Fifth Avenue Entrance / Exit Re-positioned
Hirwaun Industrial Estate

Road Safety Audit (Stage 1) | November 2008

Client: Environmental Visage Ltd Issue Date: November 2008

For the location of the points raised in this section of the report, see the Reference Plan (Figure 1).

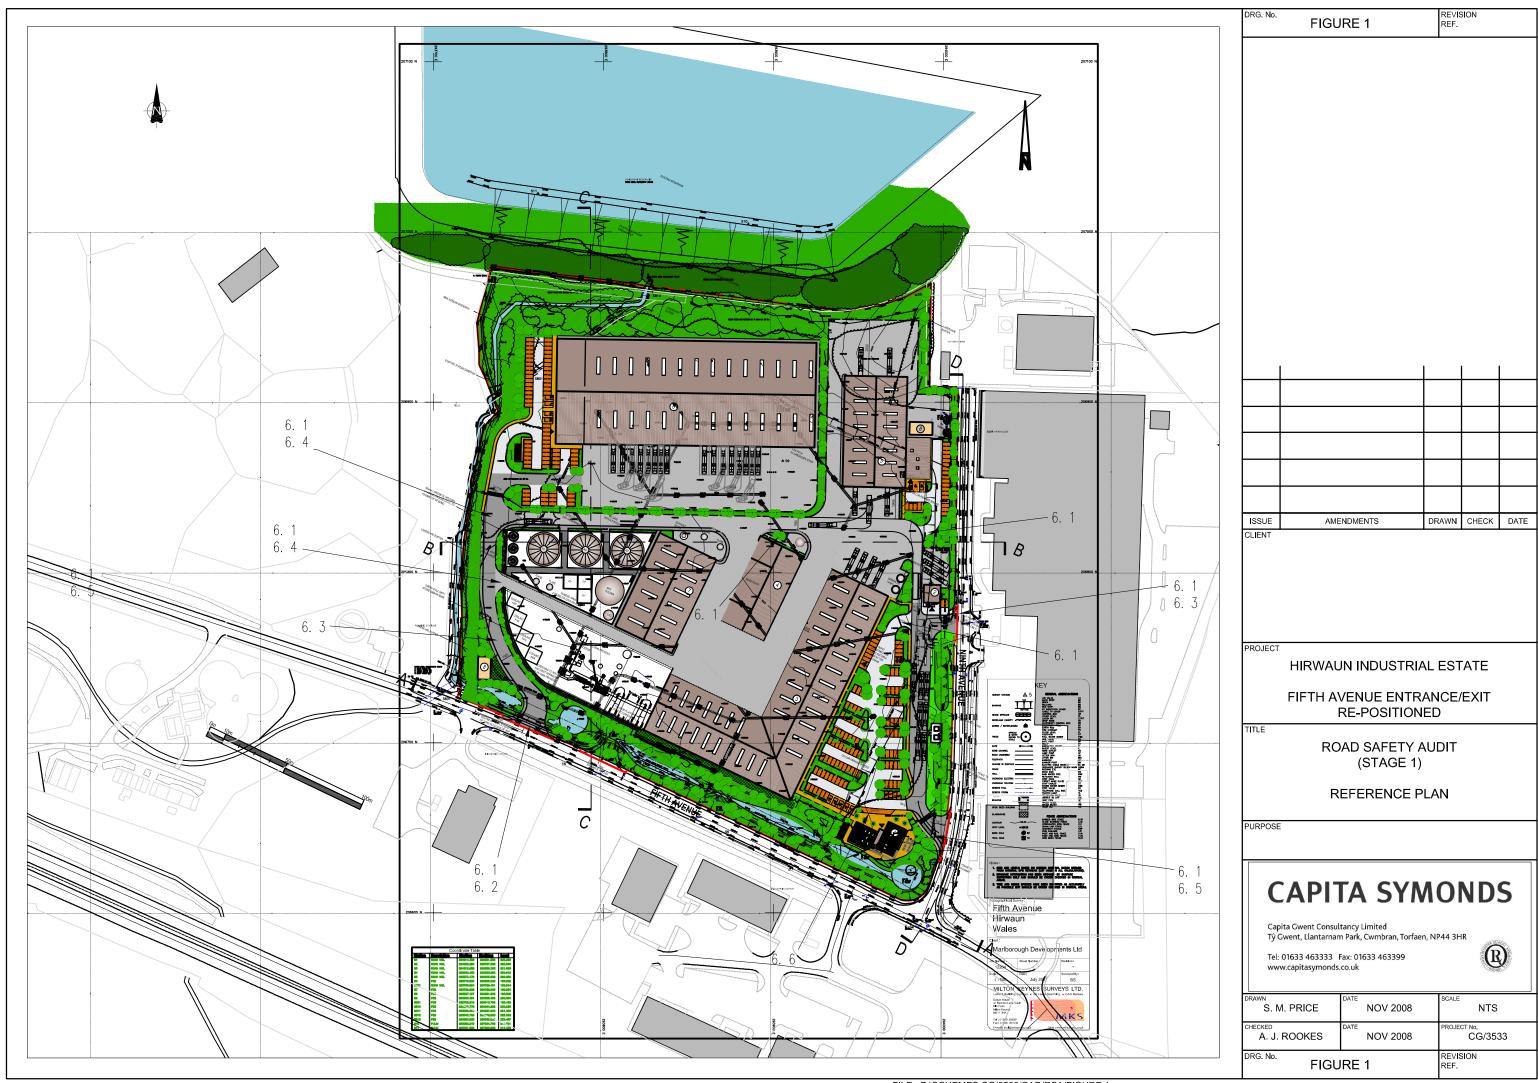
6.1 **Problem**

Location: All junctions throughout the proposed development site.

Summary: Visibility for drivers and riders emerging from side roads will be restricted by trees.

Visibility will be restricted by the trees to be provided in the verges adjacent to all junctions both within the site and where the access roads junction with Fifth and Ninth Avenue. Drivers and riders emerging from the side roads will consequently have poor visibility with resultant turning vehicle accidents.

6.2 **Problem**

Location: Junction of westerly site access road and Fifth Avenue.

Summary: The junction arrangement will create poor crossing conditions for pedestrians.

The mouth of the access road is wide and as a consequence pedestrians walking along the northern footway of Fifth Avenue will have to cross 22m of carriageway to reach the relative safety of the opposite footway. This movement will be undertaken in conflict with turning vehicles and vehicle/pedestrian collisions will consequently occur.

6.3 **Problem**

Location: The site access roads from Fifth and Ninth Avenue.

Summary: No pedestrian facilities have been provided

Apart from a short length of footway at the more southerly access road into the site from Ninth Avenue, no pedestrian facilities have been provided on the main access roads into the site. Pedestrians will consequently be forced to walk in the carriageway in conflict with passing vehicles.

6.4 **Problem**

Location: Junctions of the more westerly site access road and the Gate Control and Emergency/Maintenance accesses.

Summary: Visibility for emerging drivers and riders will be curtailed by the Greenwall.

Visibility to the left from the Gate Control access and in both directions from the Emergency/Maintenance access will be curtailed by the Greenwall. Drivers and riders emerging from the side roads will consequently have poor visibility with resultant turning vehicle accidents.

6.5 **Problem**

Location: More southerly entrance to the development site on Ninth Avenue.

Summary: Vehicles are likely to enter the development site at higher than desirable speeds.

Due to the easy entry radius, vehicles are likely to enter the site at higher than desirable speeds. These speeds will directly conflict with site activities and pedestrians who will have 20m of carriageway to cross when walking along the western footway of Ninth Avenue.

In addition, higher speed motorcyclists and possibly pedal cyclists could lose control and fall from their machines as they bank and turn on the cattle grid.

6.6 **Problem**

Location: Coach bay in the car parking area at the eastern side of the site.

Summary: Coaches will have difficulty in entering and leaving the bay.

The entry taper into the bay is short and a coach leaving the bay will have some difficulty in turning into the car park exit road without completing reversing

manoeuvres. Coaches will consequently have to complete the manoeuvres very slowly with potential shunt type collisions with vehicles entering the car park.

Recommendation

Provide visibility splays clear of all obstructions. The splays at the Fifth and Ninth Avenue junctions to be of at least 4.5 x 90m and the splays on the internal site roads to be of a dimension to suit the site speed limit.

Recommendation

Narrow the width of the junction and provide facilities to assist pedestrian crossing movements.

Recommendation

Provide footway routes into the site on all site access roads.

Recommendation

Provide visibility splays clear of all obstructions of a dimension to suit the site speed limit.

Recommendations

- 1. Tighten up the entry radius; and
- 2. Review the necessity for and location of the proposed cattle grid. This review should include the appropriateness of a cattle grid on a pedal cycle lane.

Recommendation

Modify the entry taper and exit arrangements from the coach bay to enable the movements to be completed more easily.
